Reference: 0418291

Subject: Sancrox Quarry Expansion: EPA Advice on Response to Submissions Report – Air quality

The NSW Environment Protection Authority (EPA) have reviewed the Submissions Report for the proposed Sancrox Quarry Expansion Project (Application SSD-7293). Recommendations for further analysis or explanation were provided to the Department of Planning, Industry and Environment (DPIE) on 22 June 2021, and some of these related to the Air Quality assessment. This letter summarises those comments and EPA recommendations, and provides a response for each.

Figure 8: Cumulative 24-hour average PM₁₀ concentrations at R46 for maximum daily throughput (normal operating hours)

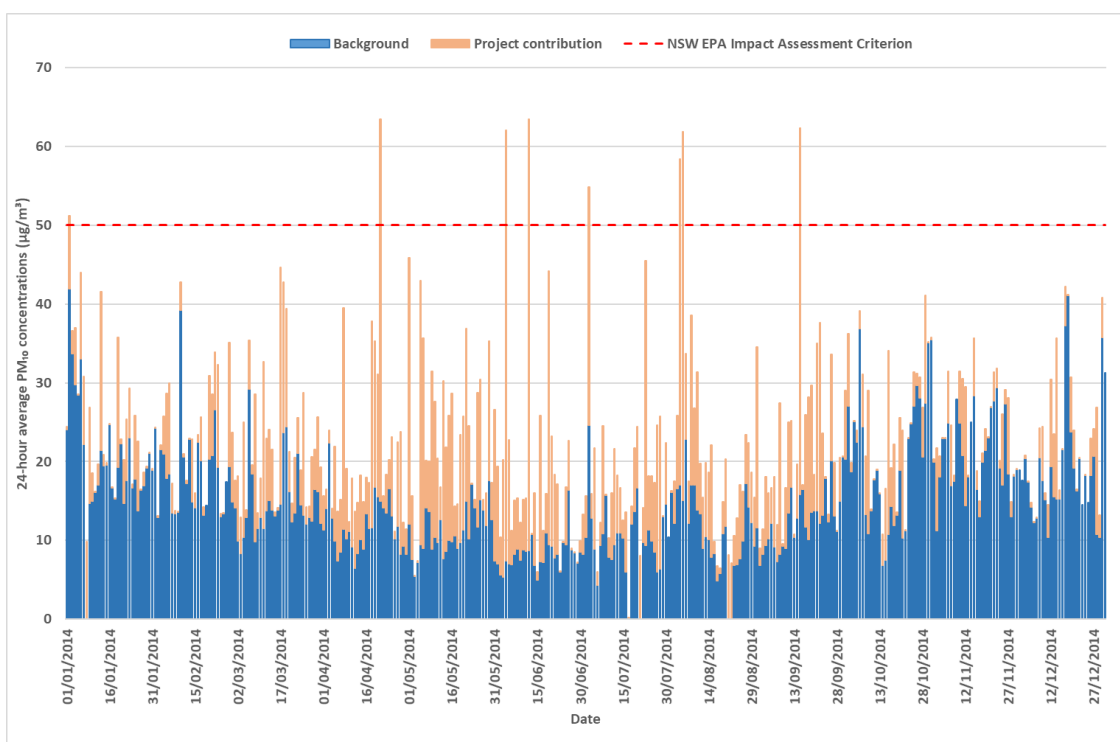
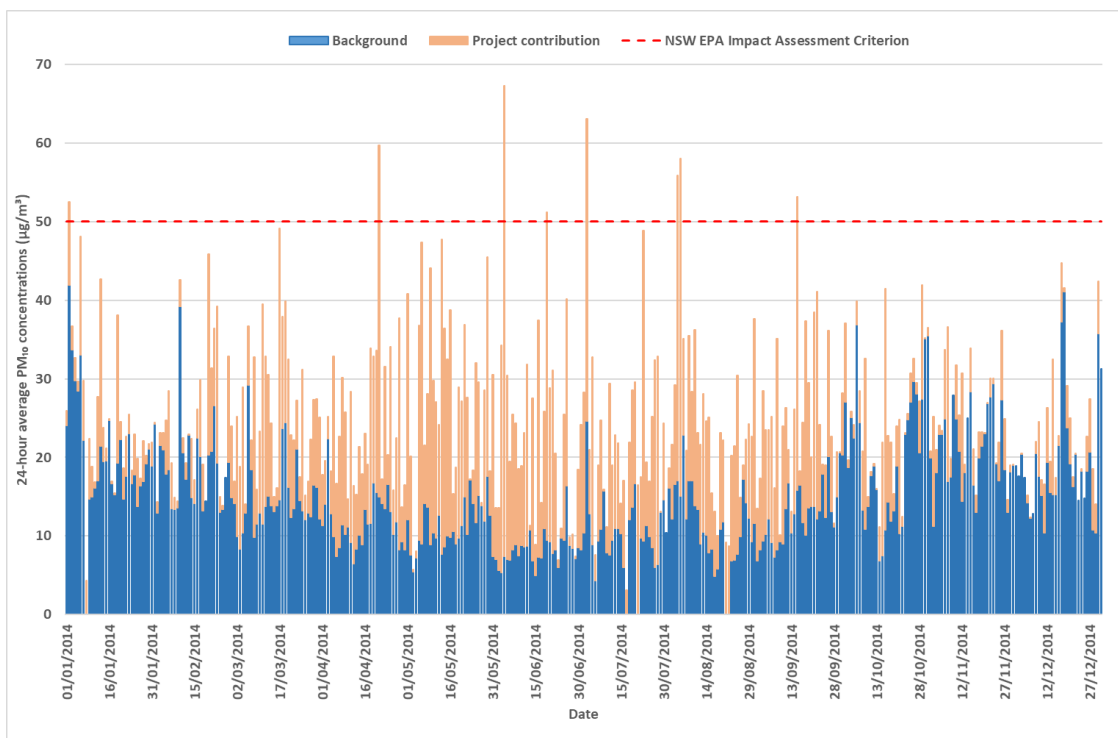
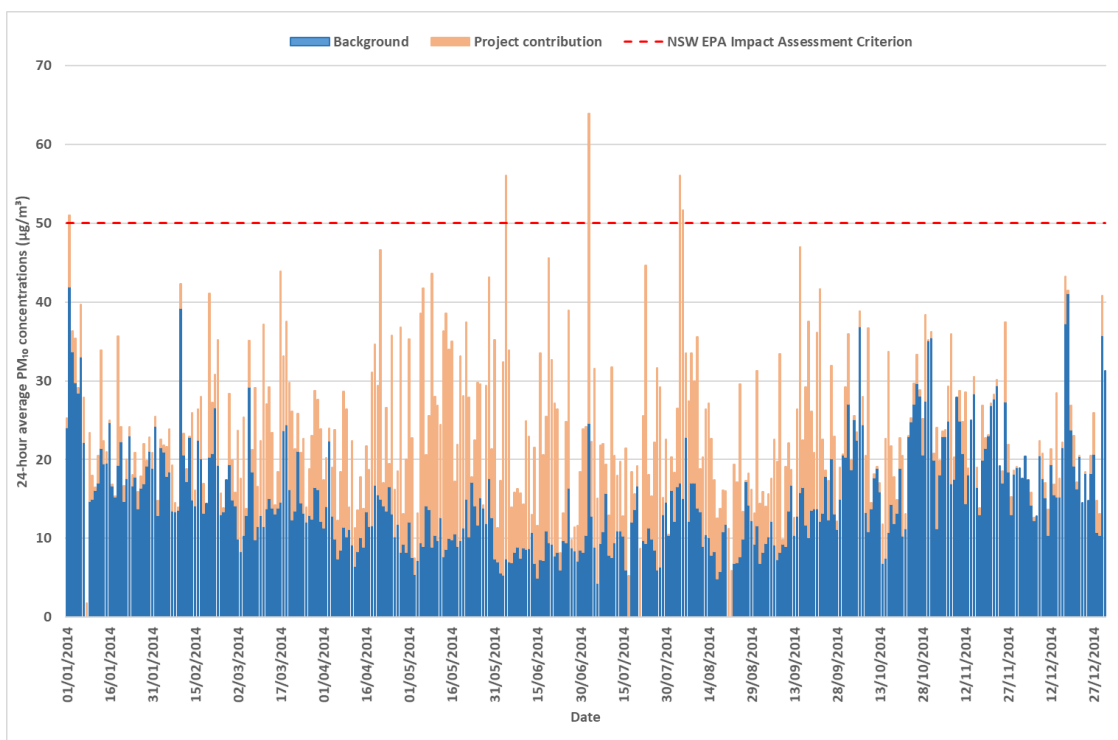
Given that it is proposed that operations may be undertaken for 24 hours during 20 days a year, a 'Maximum Day (24 hours)' emissions scenario was prepared to show the potential impacts of the 24-hour on-site operations at the maximum daily proposed throughput. Results for this emissions scenario, show that there are 3 predicted additional exceedances of the EPA's 24-hr PM₁₀ criterion at receptor R13.

Given the close proximity of receptors R46, R47 and R48 to the site boundary, it is not unexpected that from time to time there may be higher PM₁₀ Project contributions at these locations. Figure 8 to Figure 10 show time series plots for R46, R47 and R48, of the daily 24-hour averages throughout the year for both background (blue) and Project contribution (orange). It can be seen from these that while there are anticipated to be exceedances due to the Project, these are relatively infrequent given the extremely close proximity of these receptors to the site boundary.

Figure 11: Predicted 1-hour average PM_{10} Project contributions at R47, for each wind speed and direction

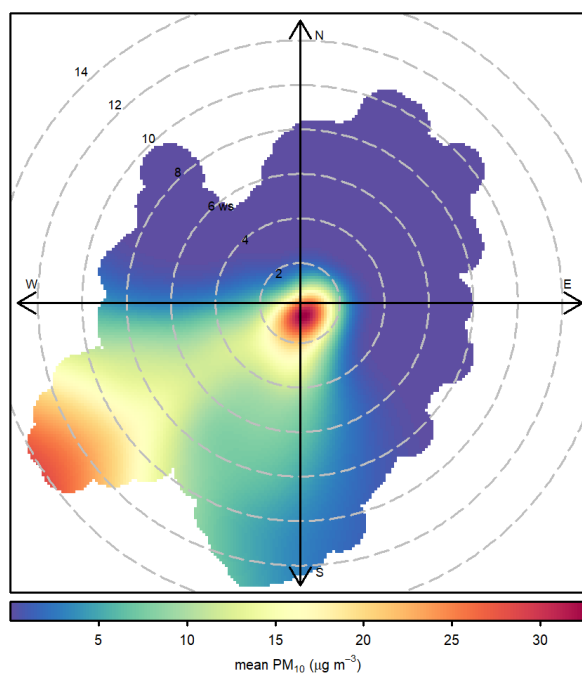
- a) Presenting cumulative impacts at receptors located immediately east of the project boundary, where the approved industrial area has been identified.
- b) Further information on the proposed control strategies to manage predicted exceedances. Including further information to demonstrate that the proposed monitoring and reactive management measures can manage predicted exceedances.

Figure 11 shows a polar plot of predicted PM_{10} concentrations at R47. These results are based on 1-hour predictions to align with the 1-hour meteorology. The polar plot shows that the highest (dark red) concentrations at R47 occur when wind speeds are low (less than 2 m/s), and predominantly from the southwestern quadrant. There are also periods of higher wind speeds (in excess of 10 m/s) when winds are from the southwest that contribute to some mid to higher concentrations (yellow to orange).

This indicates there are likely to be two main conditions that lead to higher short-term concentrations at R47. Firstly, higher wind speeds can increase emissions from sources such as wind erosion. These higher emissions do not always necessarily result in higher ground level concentrations as dispersion is generally better at these times (hence the yellow/orange shading rather than red). However, if these situations are then followed by overnight inversion conditions where winds are calm and dispersion is poor, this can lead to higher concentrations until the
